# AGENDA ITEM 5

2016/0295/DET

APPLICANT RESPONSE  
TO CONTRIBUTIONS

# CML responses to representations relating to the access track alongside the new Sheiling Tow.

# Background Landscape and Access overview

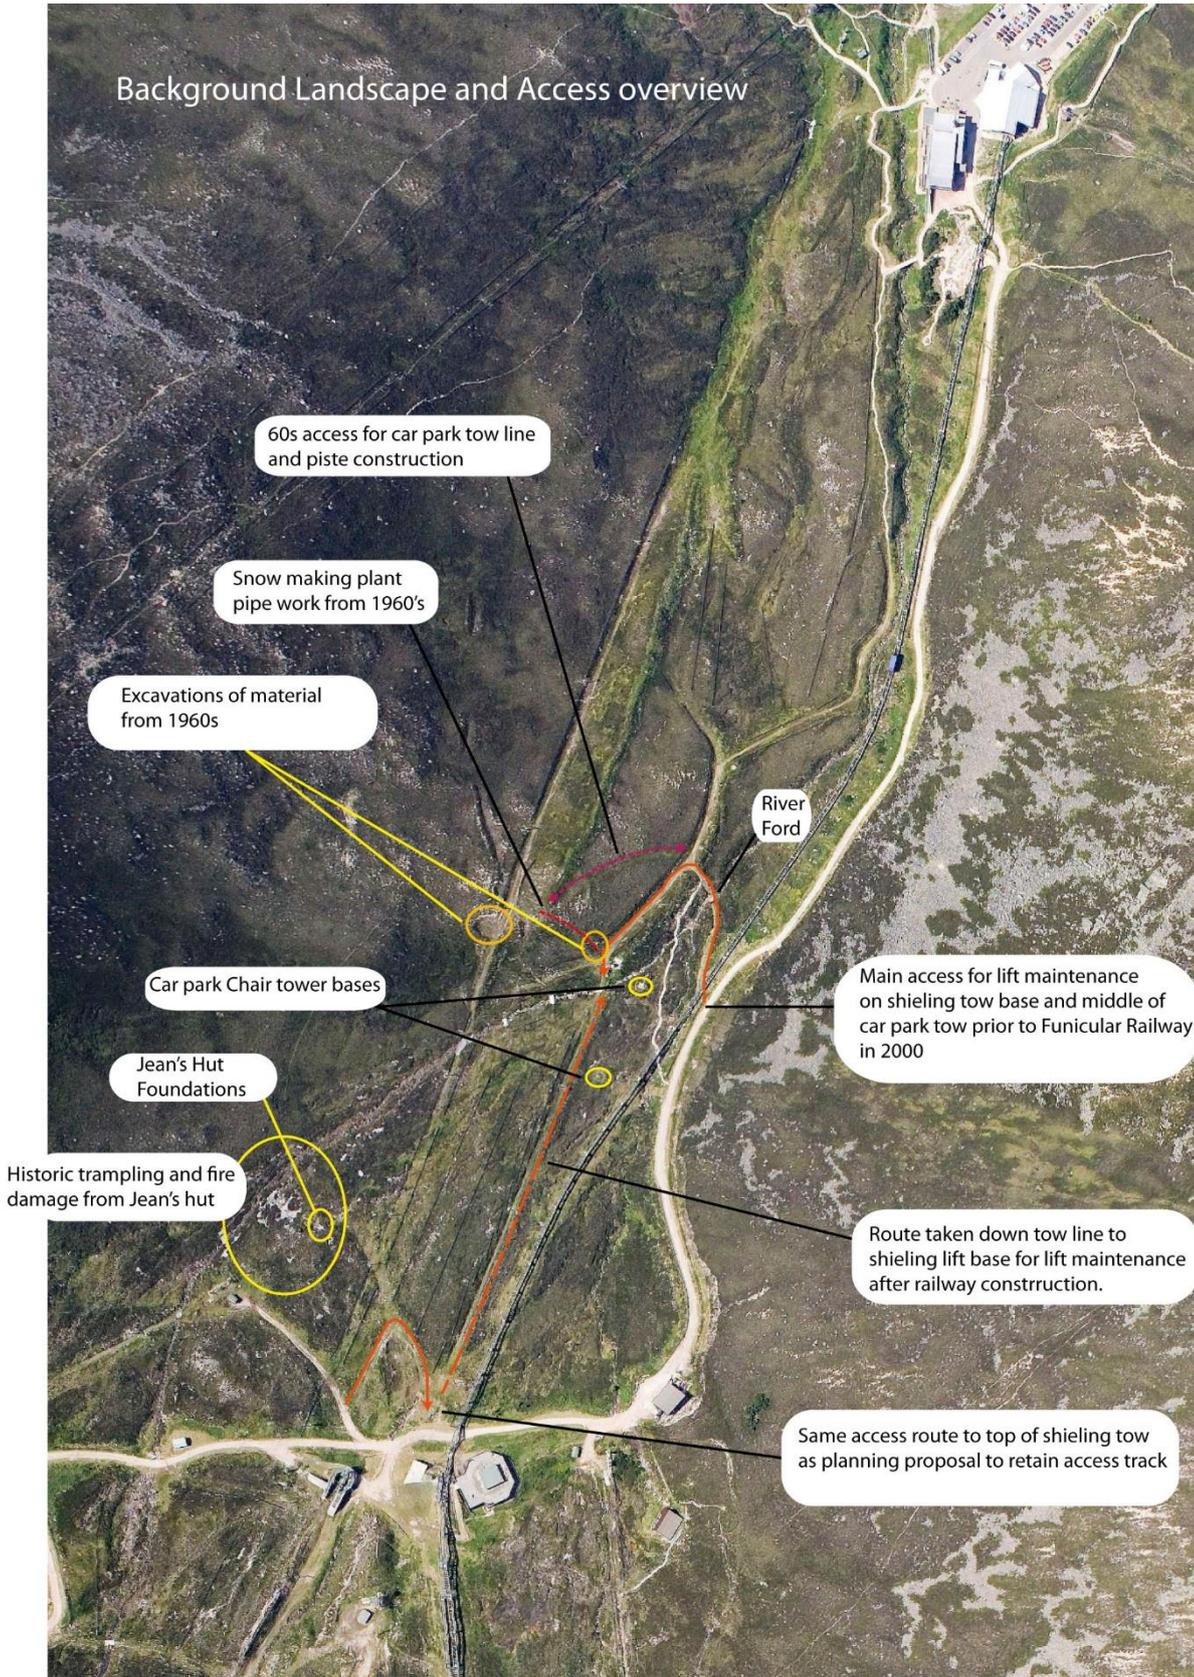
the wheel must be taken down by telehandler machine. The old Sheiling tow had two service tracks as indicated in the Landscape and Access overview annotated image. There are no interim towers as shown in the image above therefore maintenance is only at the base and return station at the top of the ski lift. The removal of the three interim towers is an additional benefit to the landscape as described in the planning approval (2014/0251/DET).

The Sheiling tow was maintained for five decades using two access tracks (see Background Landscape and access overview annotated image)
